Pennsylvania
Department of Environmental Protection

Re: Administrative Order – Response to Comments to the Fenceline Perimeter Air
Monitoring Plan and Addendum
MIPC Chelsea Pipeline Station and Tank Farm Release
920 Cherry Tree Road
Aston Township
Bethel Township
Upper Chichester Township
Delaware County

DEP has reviewed MIPC, LLC’s June 29, 2026 Updated Passive Sampling Plan. DEP does not approve the use of this Updated Passive Sampling Plan as proposed. While DEP acknowledges the inclusion of the continuation of one 24-hour canister monitoring location, DEP has additional comments regarding the Updated Passive Sampling Plan.

Figure 1

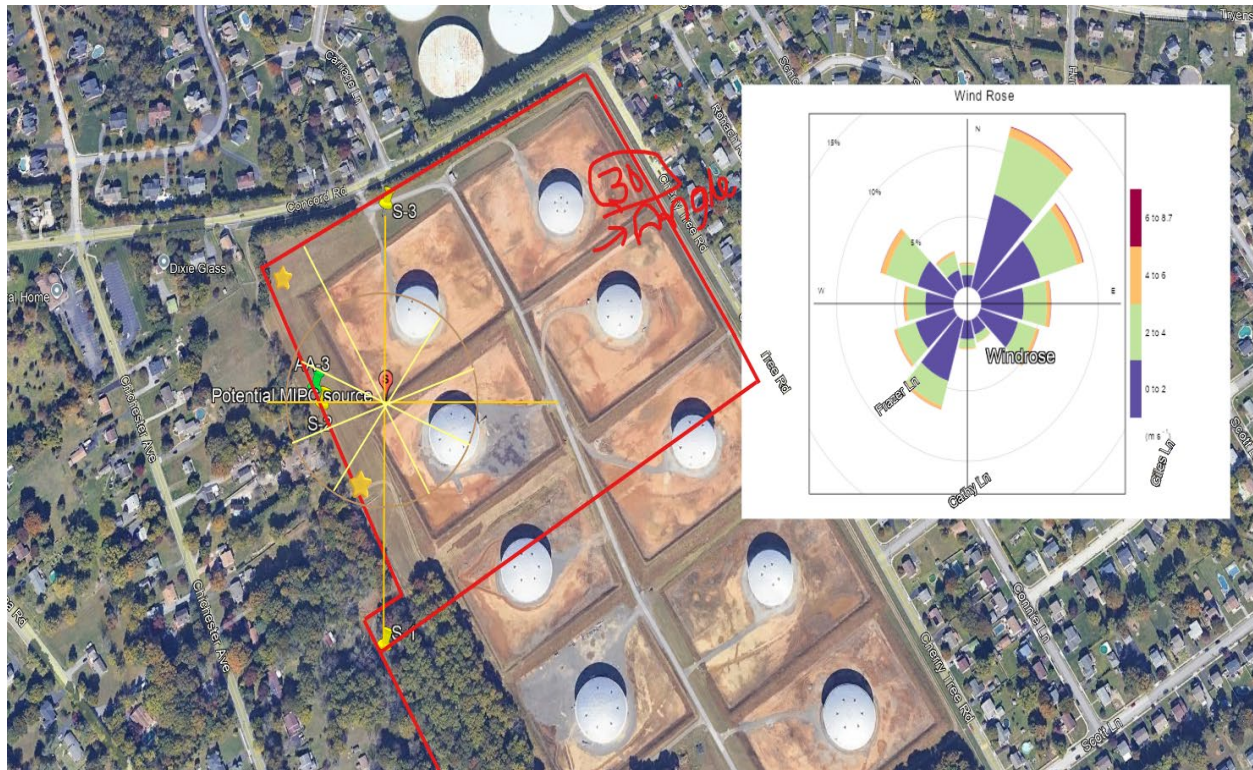
DEP recommends adding two additional passive sampling locations based on prevailing wind patterns and potential public exposure, particularly in residential areas located near emission sources. One passive sampler would be installed at the current active sampling location AA-2. The second passive sampler would be placed between active sites AA-4 and AA-3, which are positioned downwind according to the site-specific windrose.

The windrose was developed using data from the meteorological station described in the sampling plan, which continuously measures wind speed and direction from the WV weather station. In the accompanying figure (Attachment 1, Figure 1), the star symbol represents the proposed new passive sampling locations.
